PERRY CITY PLANNING COMMISSION

REGULAR MEETING AGENDA

April 6, 2023

Commercial Site Plan – Maverik, expansion of facilities on property located at 1674 W 1100 S

SHEET:
L-1
FILE NAME: SCALE:
FDG-289 1"=20'

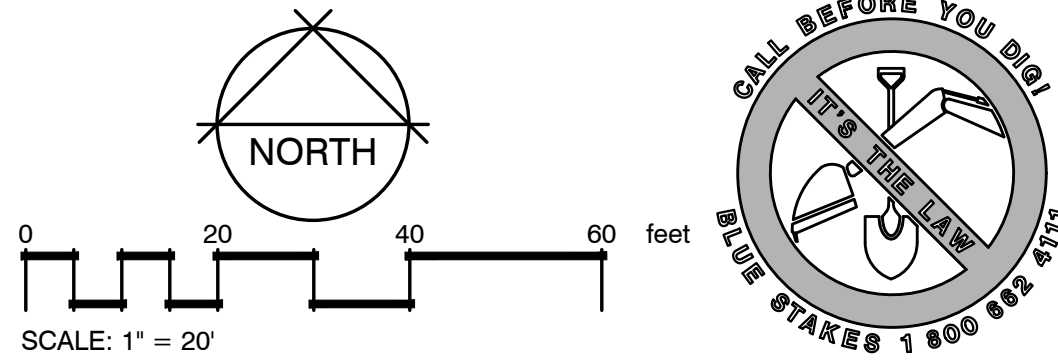
Landscape

- In 2019 Maverik expanded their site. At that time the city assumed the existing site was in compliance and that landscaping would need to be added in relation to the expanded site improvements only.

- Our code requires a minimum of 10% of the site to be landscaped; and,
 - Three trees provided per 1,000 sf of required landscaping; and,
 - Six shrubs provided per 1,000 sf of required landscaping.

- The applicant will also need to replace the landscaping shown to be removed as well as the required plant material that has died.
- Our code states, “No area of the development shall be left un-improved or without development. All areas should be developed with buildings, hard surfacing, or landscaped. No area of the lot or parcel shall be arbitrarily excluded from the site plan to avoid development requirements.” Maverik has incrementally expanded onto the neighboring properties. At this point they should follow this regulation and fully improve the property. With that being said there is a significant area to the west that could feasibly be held for a

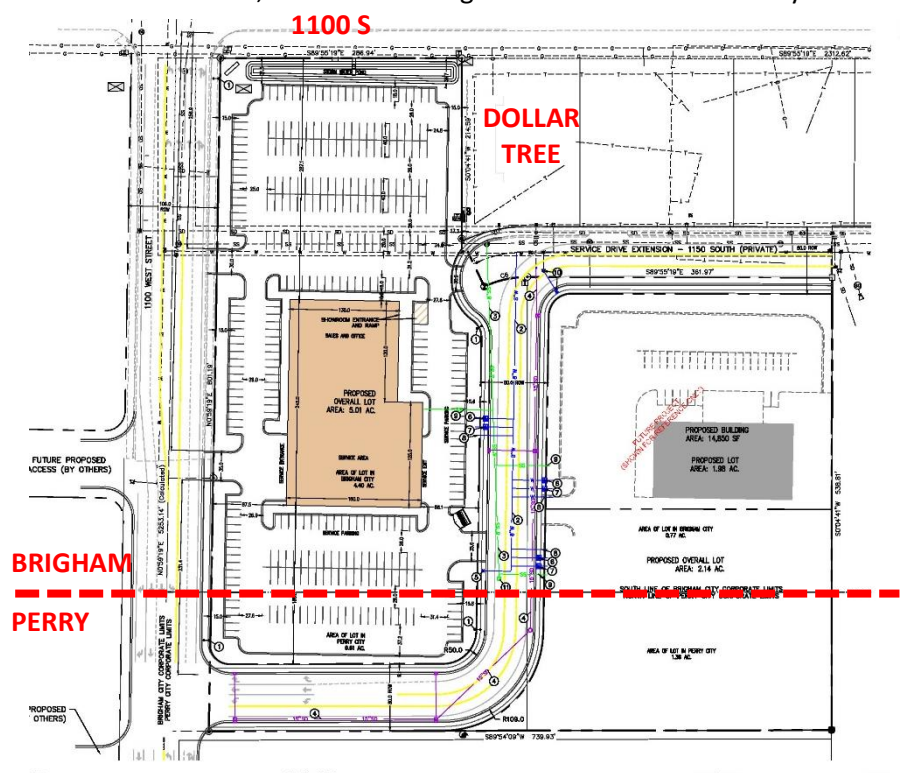
While this application needs to be reviewed and approved by Perry City, it is the recommendation of staff and our engineer that this application be approved under the condition that the entire site meets the requirements of Brigham City and those outlined by Jones and Associates. This recommendation is due to:

- Only a small portion of the site is within Perry City and this portion consists of the parking lot.
- Perry City utilities are not needed for this site, nor does our engineer recommend that they be extended to the adjacent roadway.
- Brigham City's relevant standards are similar or the same to Perry City's standards.

If this recommendation is followed then the Perry City portion of the site would need to meet the Brigham City requirements for landscaping, storm water, etc.

The applicant will need to submit a subdivision plat for approval in order to dedicate the roadways.
